**AERONAUTICAL CHARTING MEETING**  
**Charting Group**  
**Meeting 21-02 – October 26 - 28, 2021**

**FAA Control #21-02-364**

**Subject:** Airport Sketch – Final Approach Track

**HELENA RGNL (HLN)**  
**ILS or LOC Y RWY 27**

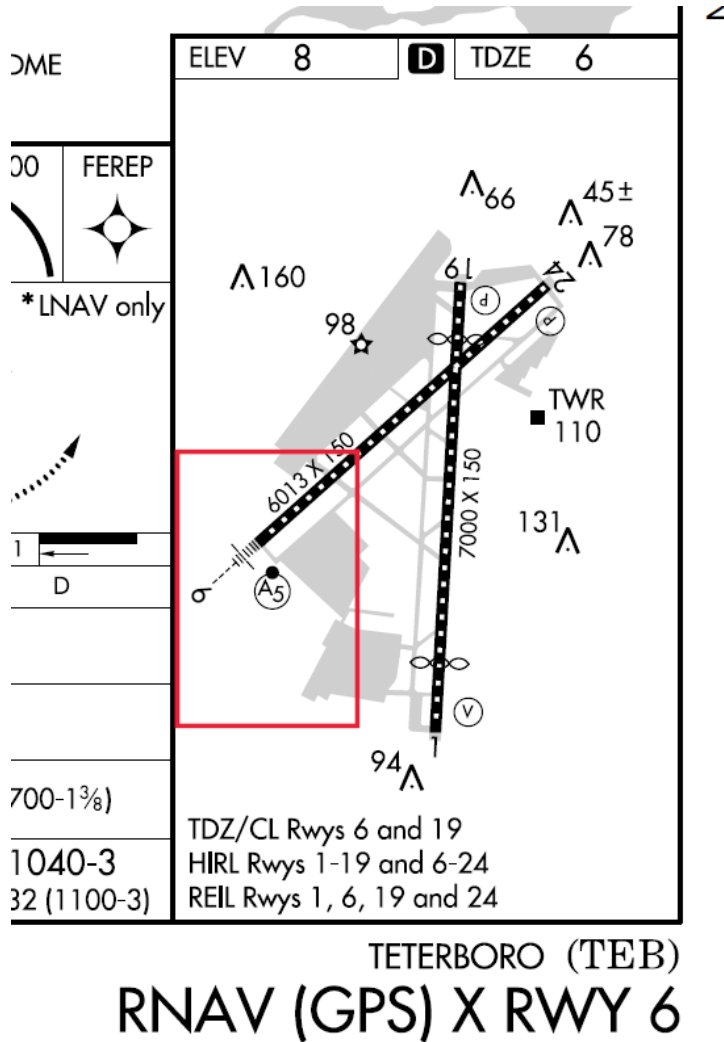
The Interagency Air Committee (IAC) Specification Document #4, paragraph 3.4.7.6 prescribes the criteria upon which the Final Approach Track is depicted on the instrument approach chart's Airport Sketch (exception: ILS CAT II, ILS CAT II & III, ILS SA CAT I, ILS SA CAT II, and ILS SA CAT I & II approaches). Here is an example for the ILS or LOC Y Rwy 27 approach at Helena, MT – KHLN:

KODIAK (ADQ)(PADQ)  
**RNAV (GPS) RWY 26**

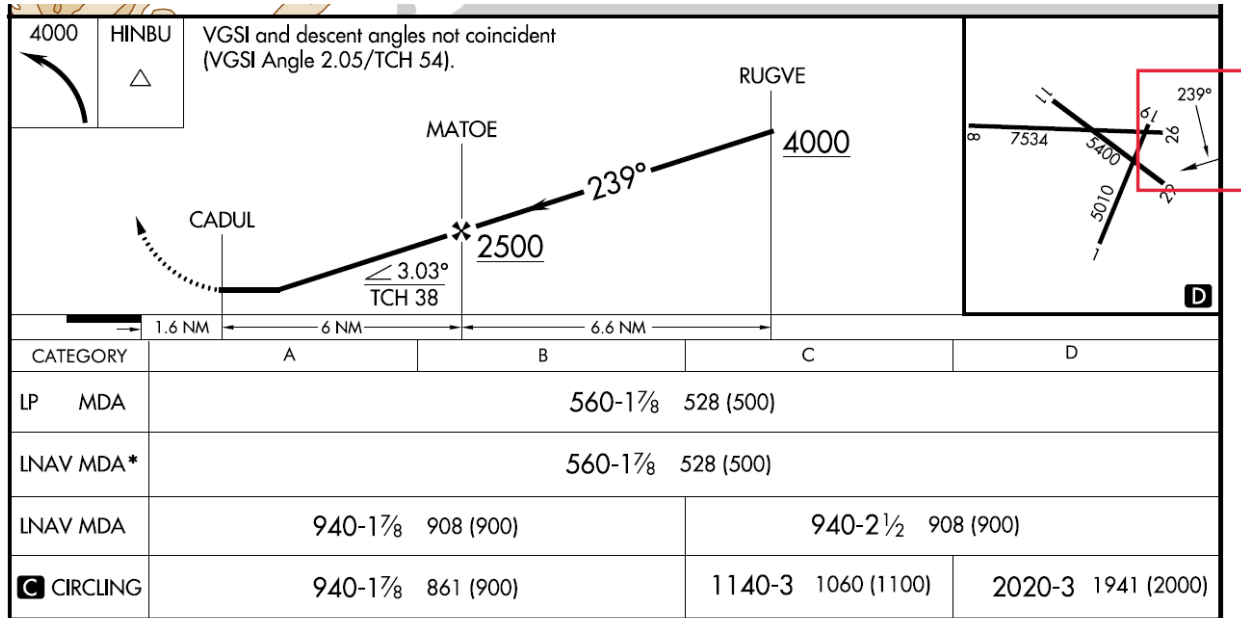
That later concern was illustrated when the working group looked at the RNAV (GPS) Rwy 26 at Kodiak AK – PADQ). In this procedure, the MAP (CADUL) is located 1.6 NM from the runway threshold. The final approach course is also offset from runway 26 by 19 degrees:

Because the MAP is located outside of the Airport Sketch, the Final Approach Track is not depicted. As part of its work, the ACM-CG working group prepared an option where the Final Approach Track was depicted on the revised Airport Sketch for comparison:

Again, there were differing opinions expressed on the depiction of the Final Approach Track when the MAP is located outside of the Airport Sketch. Pilots generally believed it beneficial to show the relationship of the final approach course to the landing runway as an aid to sighting aligning with the landing runway during the visual segment of the approach. Charting representatives expressed concern that doing so could imply to the pilot that it was safe to continue the approach beyond the MAP without the CFR-required visual references and that the course depicted by the arrow may be safely followed in such instances. There was also concern expressed that pilots might misinterpret the arrow as implying the missed approach procedure was a straight out missed instead of a turning missed, as described on the procedure.

The ACM-CG Instrument Approach Chart Modernization Working Group brings this agenda item to the ACM-CG for a determination on whether it is desirable to revise the IAC specification and chart the Final Approach Track on the Airport Sketch regardless of the location of the MAP in relation to the Airport Sketch Boundary. We ask that the ACM-CG express their desire to AJV-A and Terminal Charting concerning this specification and the need, if any, to revise this specification.
